MetroLink Oral Hearing – Module 1 February 2024

Tunnelling and Excavation Related Issues

Statement prepared on Behalf of Mouna Unlimited Company

Extract from Railway Order Drawing no's. ML1-JAI-ARD-ROUT_XX-DR-Y-03047, ML1-JAI-ARD-ROUT_XX-DR-Y-03048 and ML1-JAI-ARD-ROUT_XX-DR-Y-03049

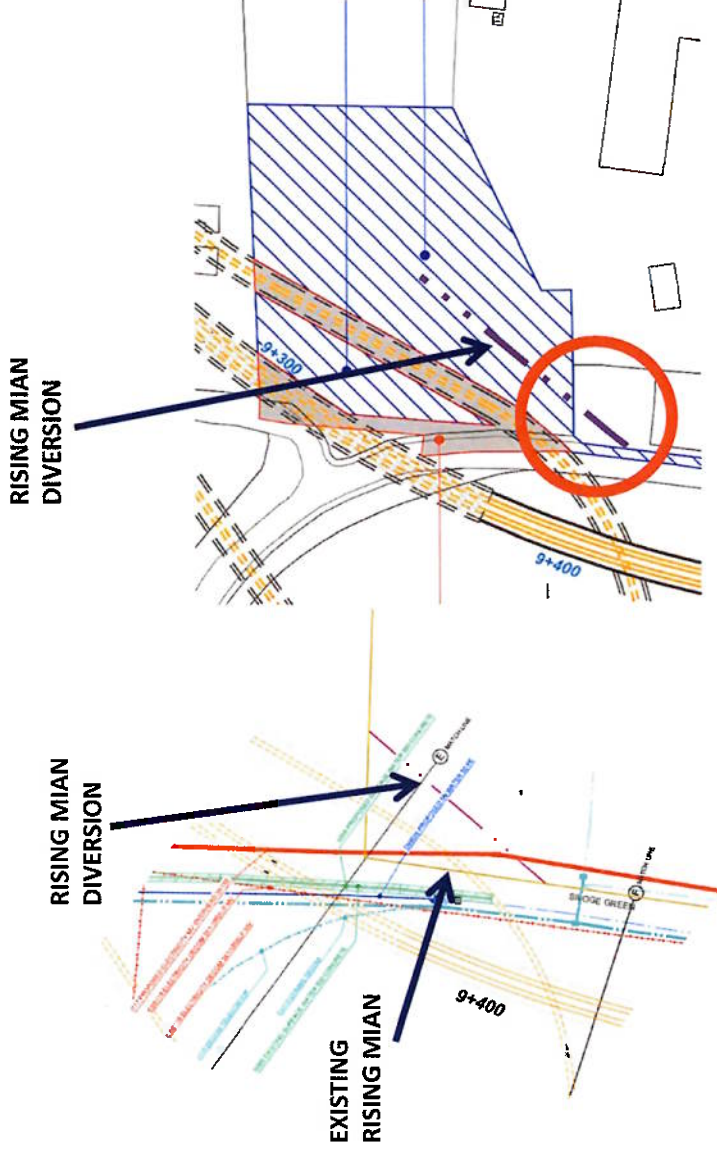
It is proposed to excavate 4 no. cut and cover railway tunnels along the existing access road to the Site. These are shown numbered on the adjacent drawing

The tunnel at location No. 4, which is located within the Site, will directly impact the private foul water rising main.

TII proposes to divert the private foul water rising main at this location to facilitate excavation of the tunnel.

Extract from Railway Order Drawing no.
P0100011S2TXDR303_XXPATIIML
(Received from TII by email on 02/02/2024)

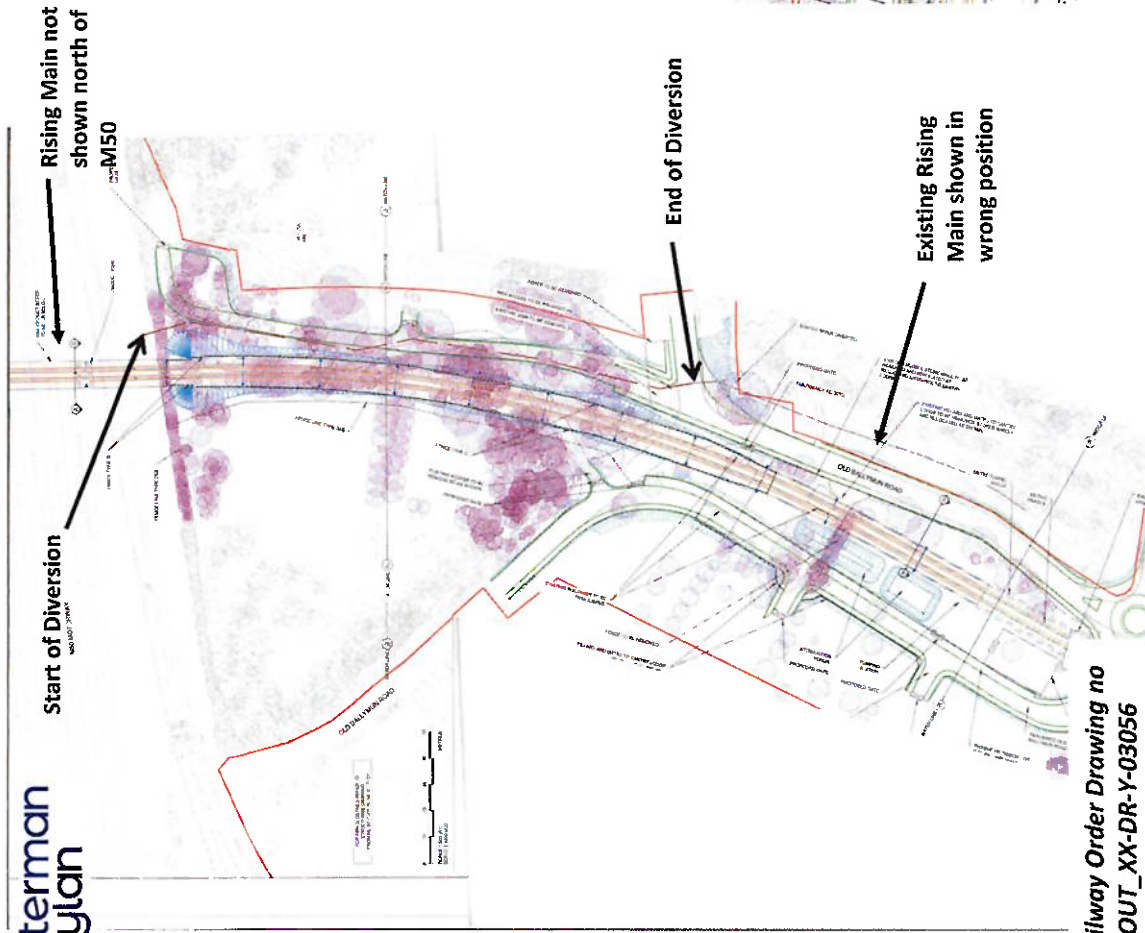
The land take required for the diversion of the rising main does not appear to be included in the property plans (circled red) circulated as part of the application

If TII were to try to divert the main within the temporary land take it will be near impossible to construct the tunnel without damage to the rising main due to its close proximity.

Mouna and Frylite have grave concerns that the lack of adequate space to divert the private rising main will give rise to potential for damage to the rising main which will impact the operation of the Site.

Extract from Railway Order Drawing no
ML1-JAI-ARD-ROUT_XX-DR-Y-03056 (rotated 90 degrees)

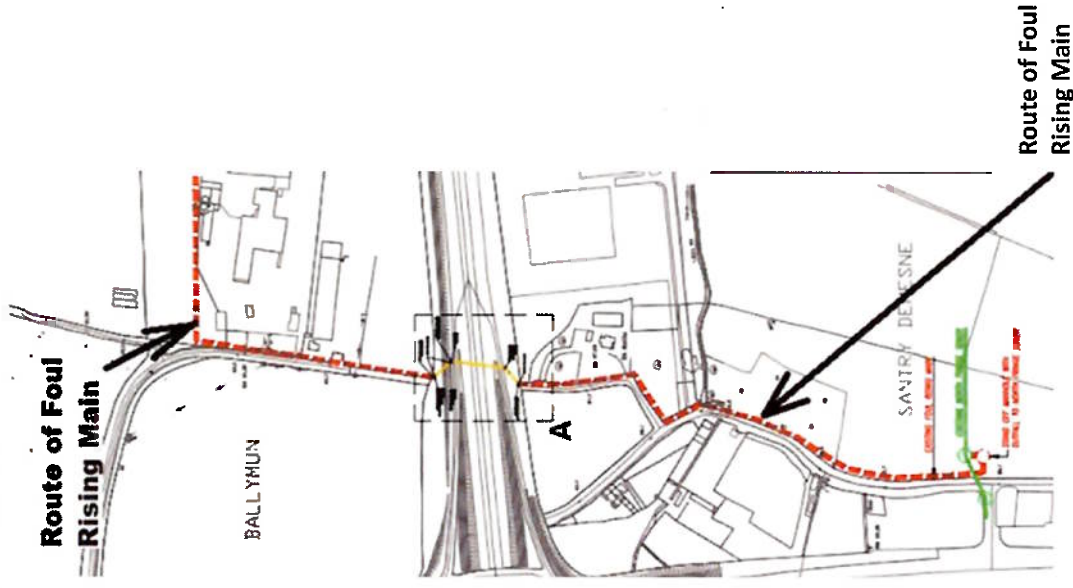
The second diversion is south of the M50. TII has provided us with a drawing for the proposed diversion.

The drawing is lacking in detail.

The existing private rising main crossing the M50 and to the North of the M50 is not shown and the impact of the proposed works has not been considered.

The existing private rising main which is indicated to the south of the proposed diversion would appear to be shown in the incorrect position.

Some of the works shown on drawing no. ML1-JAI-ARD-ROUT_XX-DR-Y-03056 appear to be outside the red line.

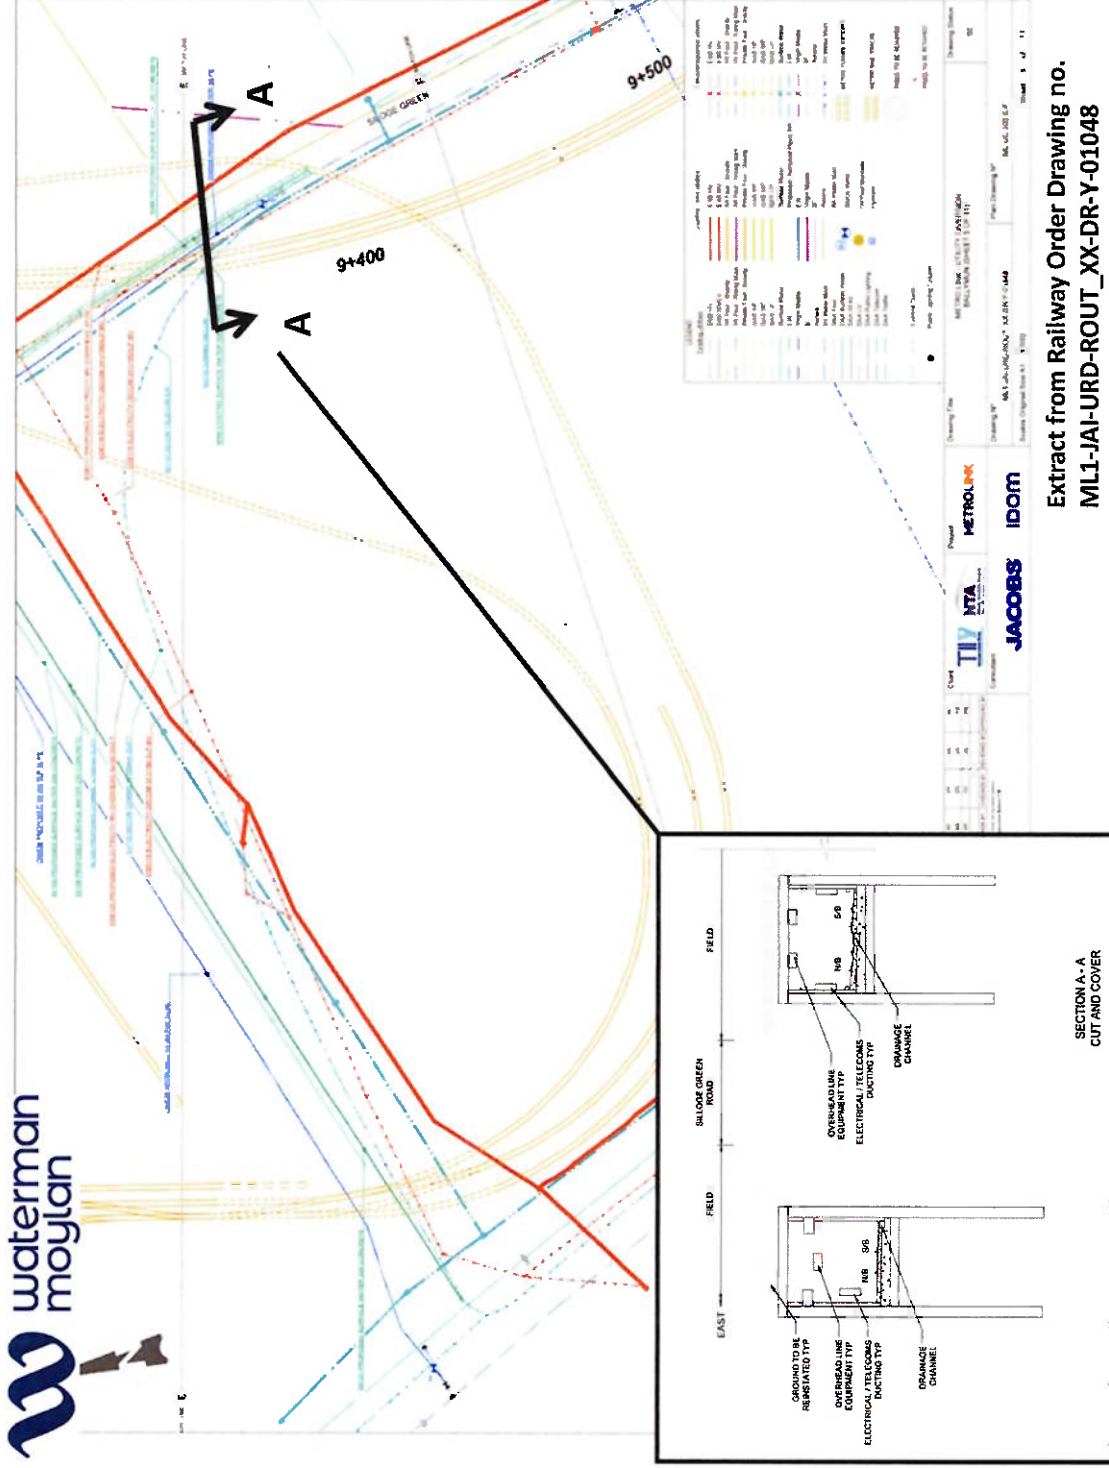
In the cut and cover sections of the railway tunnels (See section A-A opposite) the cover over the tunnel appears to be minimal. Mouna would have very serious concerns regarding any future services that they may have to install to service their existing or any proposed new development on their land.

It is assumed that there will be restrictions to works above the tunnels. Mouna would seek provision for future services to avoid the need to excavate over the railway tunnels post completion.
